Technical Service Bulletin: tsb100374

Released Date: 02-Aug-2005

CM870 Shutoff Solenoid Groove

05c00234

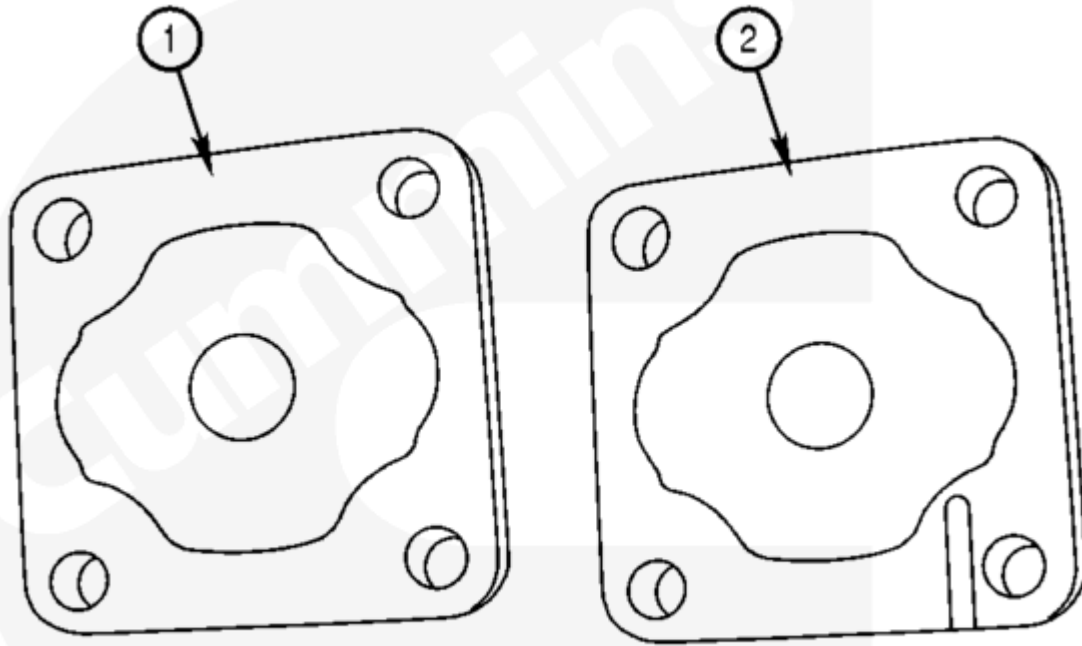
This Technical Service Bulletin provides information on the new shutoff solenoid stator for the Signature and ISX with CM870, and QSX15 series engines. The shutoff solenoid stator incorporates a new groove located on the shutoff valve coil. A groove has been added to the face of the fuel shutoff solenoid stator to improve the assembly process. The groove will help detect missing shield gaskets during assembly of the integrated fuel system module. The revision is functionally transparent to the field; however a difference on the face of the solenoid stator will be seen.

Illustrated below are the old shutoff solenoid stator (1) and the new shutoff solenoid stator (2) with the groove.

Engines built after March 8, 2005 will use the new single post shutoff solenoid stator with the groove. Shutoff Solenoid Kit, Part Number 3408421 RX/NX, which has **not** changed, was implemented in production on March 8, 2005.
